○ Timing to be activated the hazard lights

Road Speed Limit

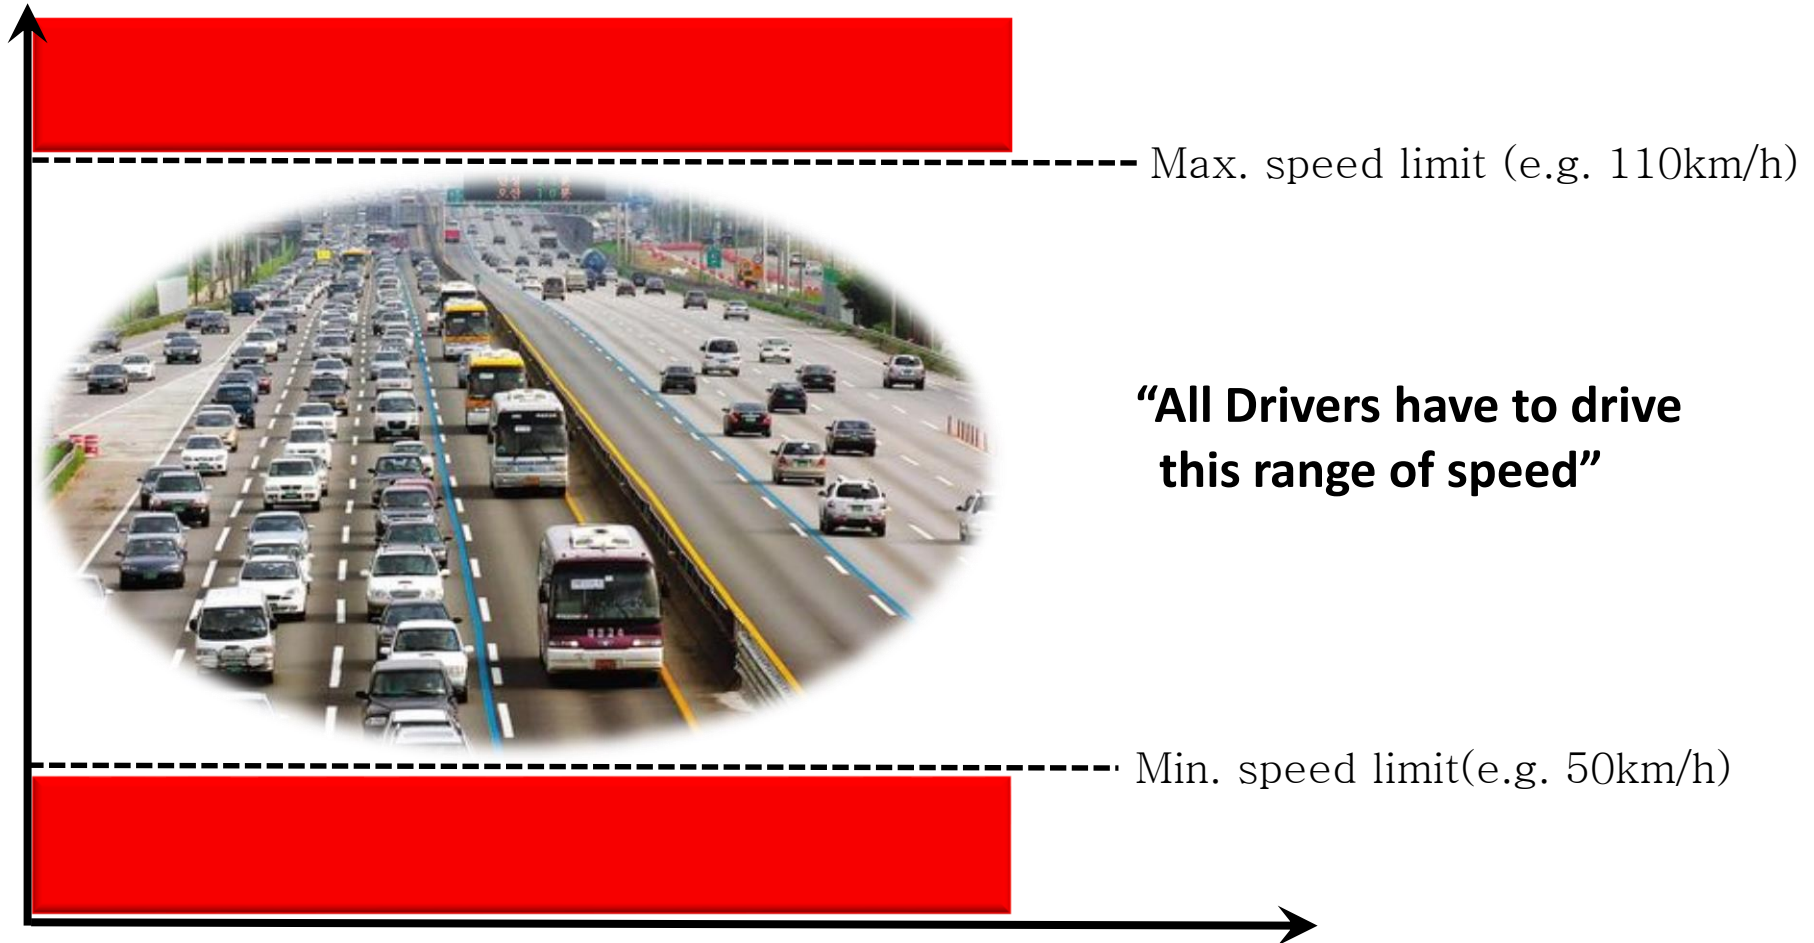
- Road speed limits are used in most countries to set the maximum/minimum speed at which road vehicles may legally travel on particular stretches of road
- All drivers have to drive vehicles at a speed of between the max. speed limit and the min. speed limit by the Road Traffic Act.
- In case of Republic of Korea/Japan, the max. speed limit is 110/100km/h and min. speed limit, 50km/h and in case of Germany, the recommended max. speed limit is 130km/h and the min. speed limit, 60km/h

- It is too long for the hazard lights to be activated automatically within max. 10 s after the start of MRM(e.g. minimizing risk by braking). This is why ACSF vehicle stops after about 10 s if ACSF vehicle decelerates with 3.7m/s^2 (feasible deceleration under wet conditions of 5.6.1.1.8.1) from 130km/h (specified maximum speed) .

- To be activated the hazard lights after stop of ACSF vehicle is too late to inform an emergency situation to other road user. Eventually, that could cause rear-end collision, etc. due to low driving speed below min. speed limit

- Therefore, the hazard lights are necessary to be activated automatically before reaching min. speed limit by the Road Traffic Act.
- Example is like below

- ⇒ Germany : $(130 - 60)\text{km/h} @ -3.7\text{m/s}^2 = 5.3 \text{ s}$
 - ⇒ ROK : $(110 - 50)\text{km/h} @ -3.7\text{m/s}^2 = 4.5 \text{ s}$
 - ⇒ Japan : $(100 - 50)\text{km/h} @ -3.7\text{m/s}^2 = 3.6 \text{ s}$

- In conclusion, Republic of Korea proposes 3 options as below:

5.6.1.5.3. The hazard lights shall be activated automatically

1) not later than 4 s

2) before the speed of vehicle falls below a minimum speed limit on road the vehicle is driving

3) 1) or 2), whichever is later

after the start of the minimal risk manoeuvre.
